Ayesha Clothing Company Ltd.

(Printing Unit -2)

14 August 2023

Observations

COLUMN SCHEDULE OF NEW COLUMN

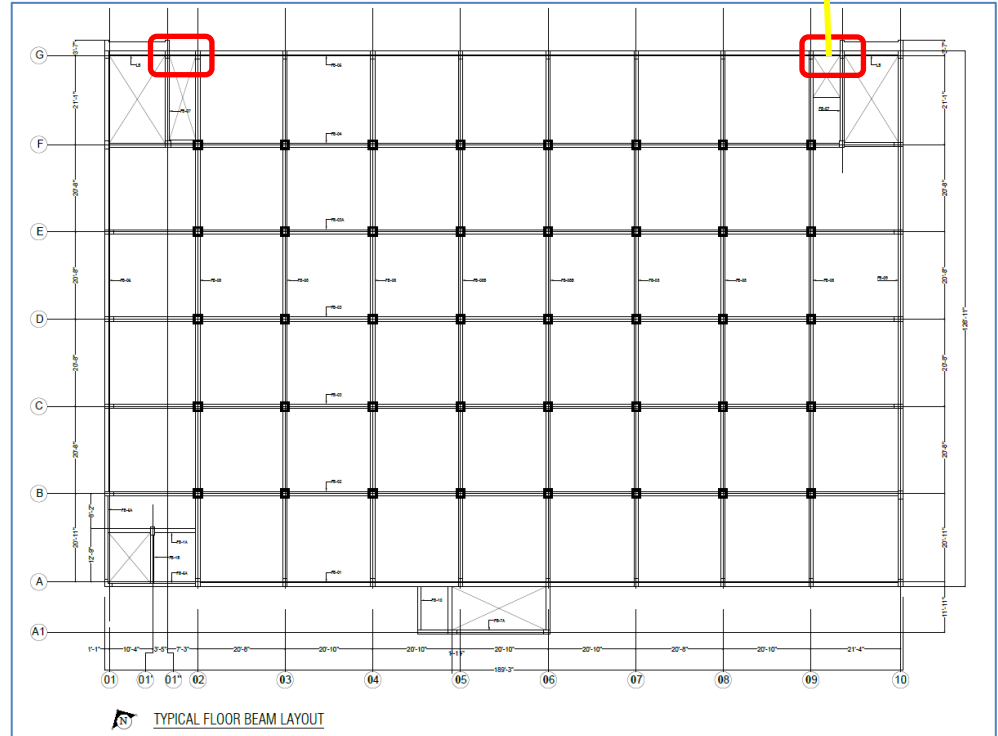
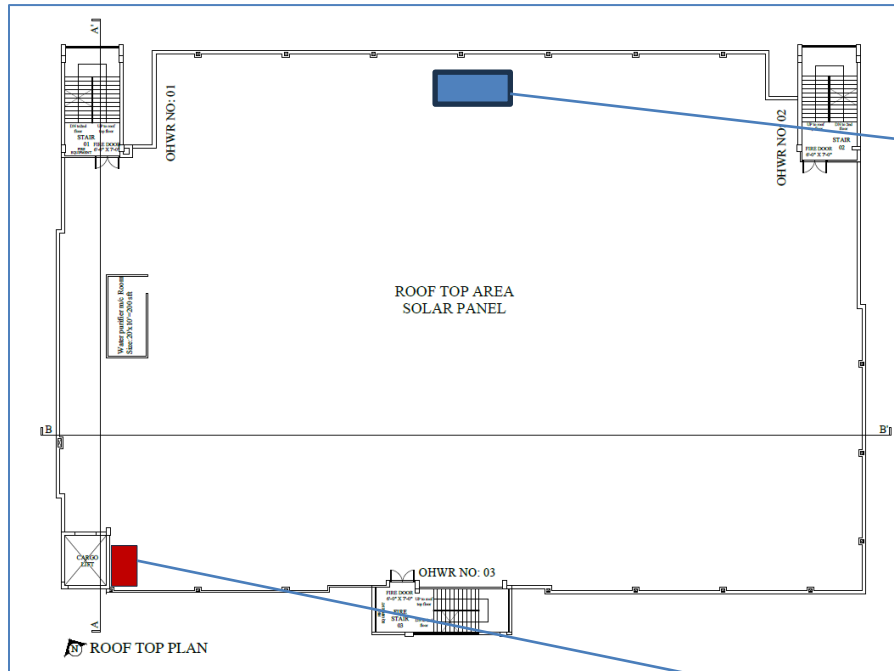
Number of rebar at C-7 column found less than the drawings. At shorter face 3 nos of rebar was found whereas drawings shows 4 nos. Also, beam Layouts are not fully matched with site condition. Mismatches are shown in red on the beam layout.

BTS room and AC outdoors were not shown in the roof layout and load plan. Building engineer is required to revise the survey the as-built condition and prepare full set of as-built drawings. Also, update the design report addressing the mismatches and applying the additional load of BTS room & AC outdoors.

Dampness at ceiling and water ponding at roof

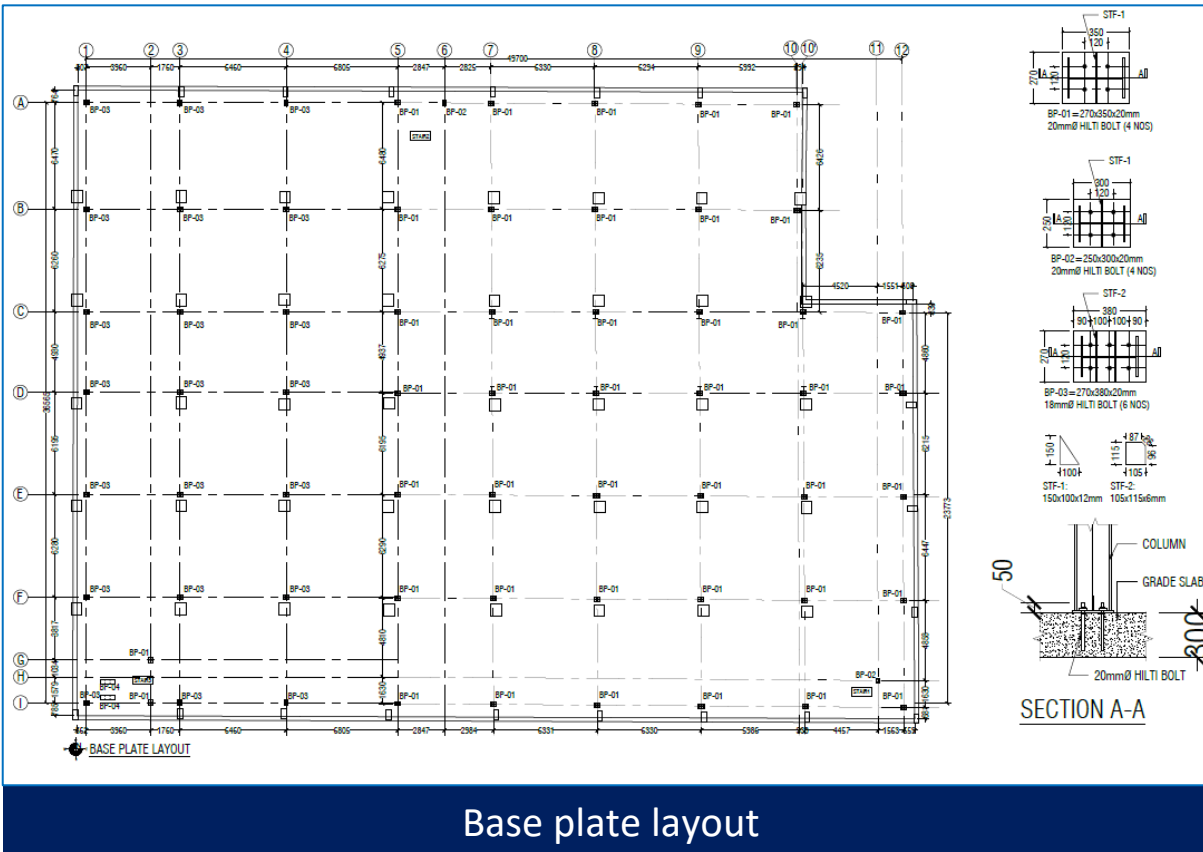
Dampness at ceiling and water ponding at roof was observed during inspection at Building L.

Distorted steel column

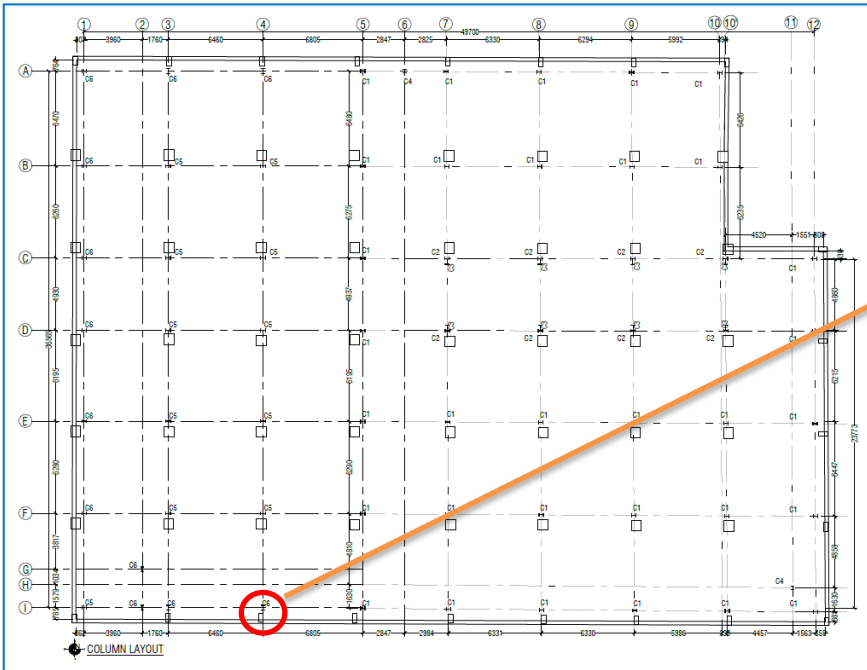
A distorted steel column found on ground floor at steel mezzanine. Stability for the distorted columns and related elements need to be checked. Factory Engineer to review design, loads and column stress in the area identified above.
